RE: Oldcastle Coastal Facility – 1200 NW 18<sup>th</sup> St., Pompano Beach, CPTED/Security Public Safety Plan

I have been contracted to review the drawings for security and Crime Prevention Through Environmental Design (CPTED) features in the proposed Oldcastle Bonsal Facility site plan update that is being considered for permitting by the City of Pompano Beach.

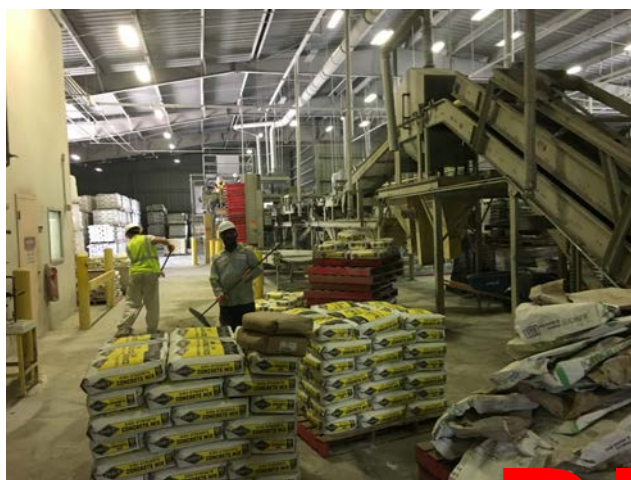
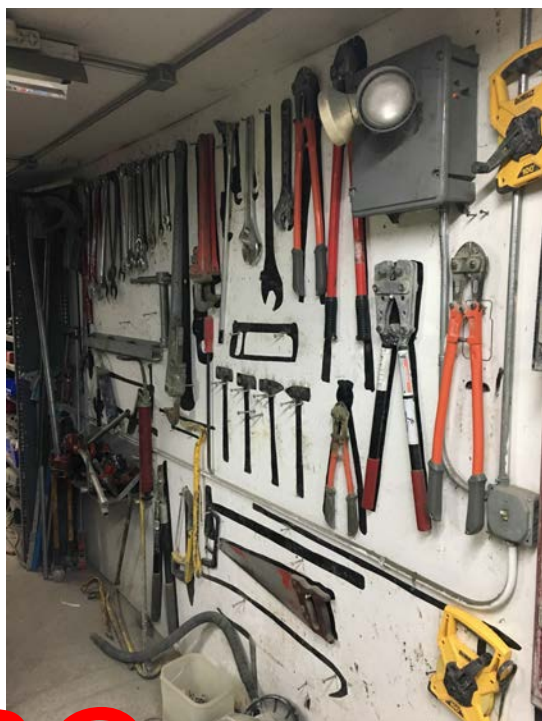
Tools and equipment is an attractive asset that need to be protected.

Forklifts and product stacked are assets that need to be protected.

Tools and machinery must be protected from loss, theft, pilferage, or vandalism.

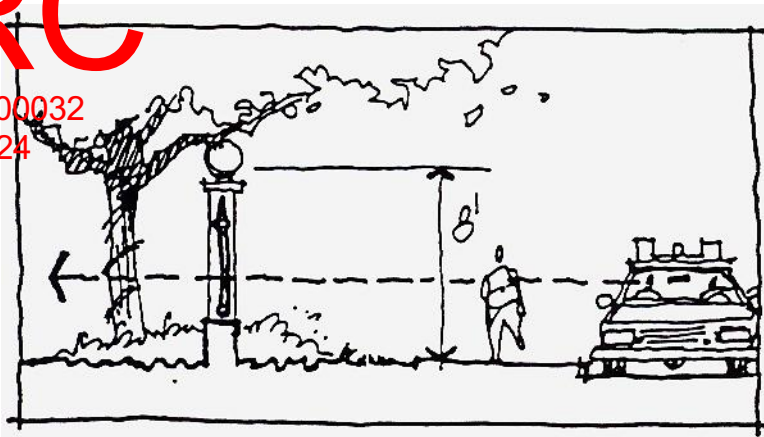
The pictures above are examples of vehicle gates and creating a secured entrance for company deliveries and vehicles.

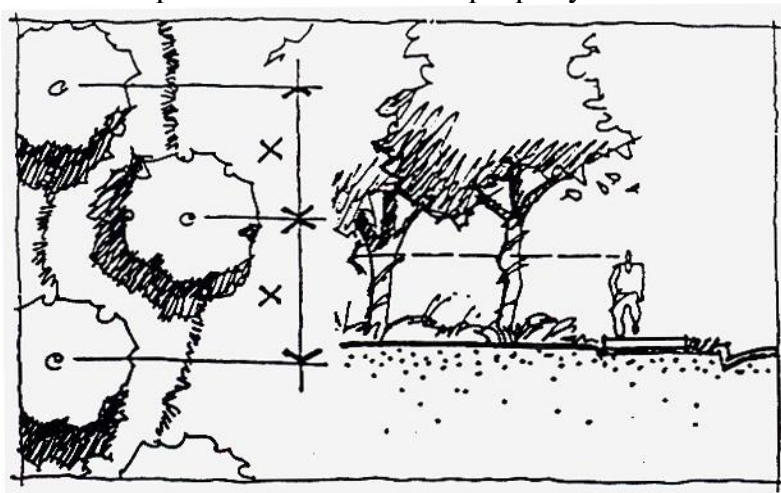
Natural surveillance – Natural surveillance is accomplished on the site by having a chain link fence on the north, south, and east boundaries. The west side boundary is being proposed to have decorative attractive code complaint decorative fencing and vehicular gates to create an entrance that allows open visibility by employees and staff and video surveillance. Police patrol will be able to readily discern any inappropriate or suspicious activity on the exterior of the fence, and see over the low shrub boundary, and under the tree canopies.

Ground plantings and hedges should be less than 3 feet and tree canopies over 8 feet to allow a clear zone of natural surveillance for police to be able to have un-obscured sight around the perimeter and into the property.
